FURTHER OBJECTION TO DEVELOPMENT PROPOSALS MP_07 0166

MOD 8

MP07_0166 Mod 8 is an application seeking to modify the Wahroonga Estate Concept Plan by providing detailed amended residential building envelopes and amended residential car parking rates for Precinct B: Central Church Precinct. The modification does not seek to alter the total maximum dwellings approved under the existing Concept Plan.

indicative solar access diagram

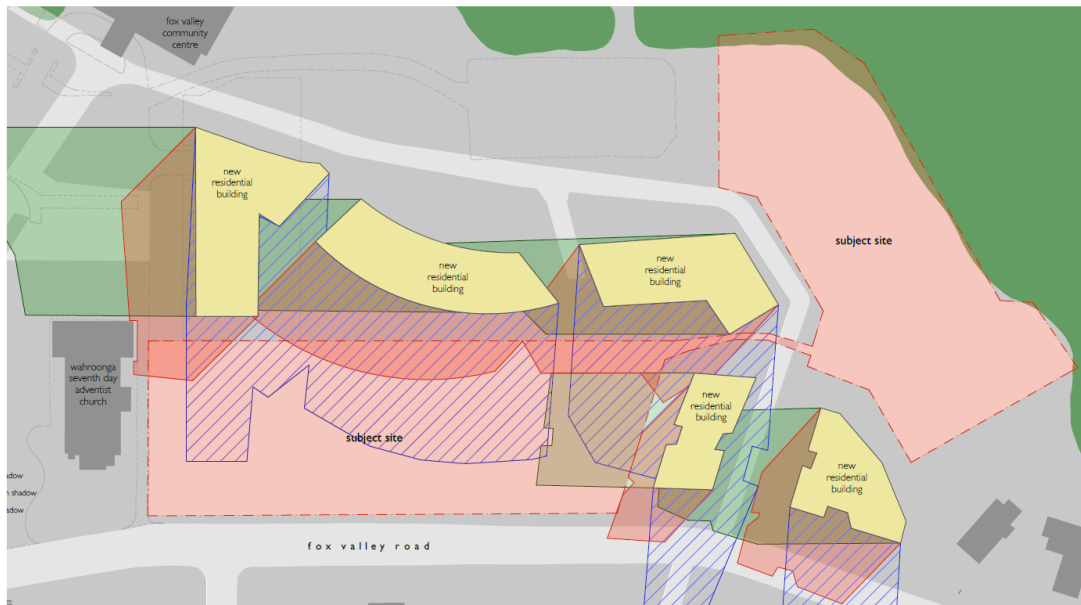
Whilst the amended plans, have amended the location of the building envelopes slightly, it can be seen from the above diagram that a large proportion of the school site will remain in shadow. Accordingly, it is considered that the concerns remain valid and the proposal will result in negative adverse impacts on the adjacent school site. The proposed Mod 8 application to increase the height planes and height limits of the buildings should not be approved and the detailed floor plans should also not be approved for the above reasons.
